VILLAGE DISTRICT CONSULTANT

1708							
DATE:	January 23, 2024						
APPLICANT:	3 Big Shop Lane						
	Terrace (platform)						
MEETING LOCATION: Town Hall Annex Back Lower Level Conference Room							
VDC MEMBERS: (Place check next to the	naa wha attandad\

Land Sandra Mary Charles					
DATE:		January 23, 2024				
APPLICANT:		3 Big Shop Lane				
			Pergola & Vestibul	<u>e</u>		
MEETING LOCATION:		Town Hall Annex Back Lower Level Conference Room				
VDC MEMBERS: (Place check next to those who attended) ☒M. Ascher ☐S. Benton ☒J. Goldfluss ☐J. Heyman ☒J. Kinnear ☐G. Lounsbury ☒P. Maggi ☒S. Schrager						
ALSO PRESENT: Pietro Polini						
APPLICATION:	⊠Sp		. – New Building It – Additions vation	Site Plan Approval Signs Other:		
ACTION:	⊠ VI ⊠Ad	OC recommends design approval as noted OC does not recommend design approval dditional design studies/information requested her:

Attached is the photo of the building as originally approved by P&Z.

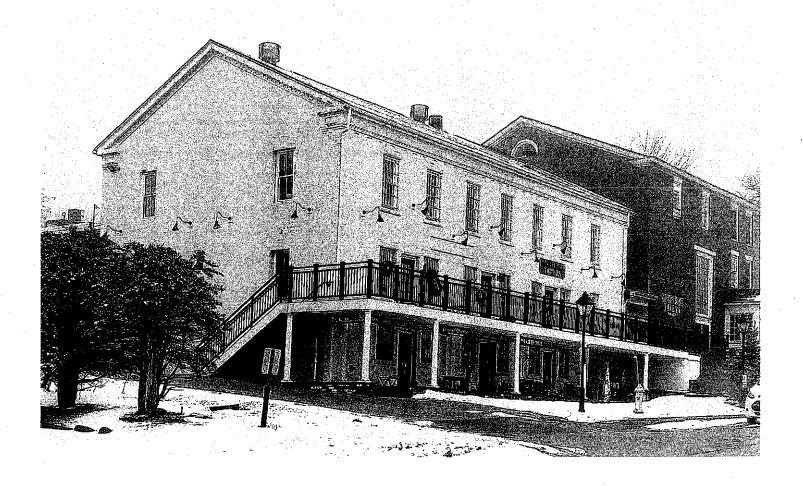
The design of the main façade of the Big Shop is obscured by all 3 additions. The metal and glass vestibule structure has no relationship to the materials of the existing building. If its function is to prevent winter drafts, a seasonal, removable fabric enclosure would be a possible solution.

The pergola design in metal and plastic panels is not compatible with the architecture of the structure or surrounding buildings. The stone tiles at the gable and the untrimmed circular window are also not in keeping with the existing façade, which was cedar shingles in the gable and brick below. A solution would be a roll-up awning for shading some outdoor seating, as long as it does not block pedestrian use of the brick sidewalk. Cedar shingles or clapboard in the gable with a square mullioned, trimmed window would be more appropriate.
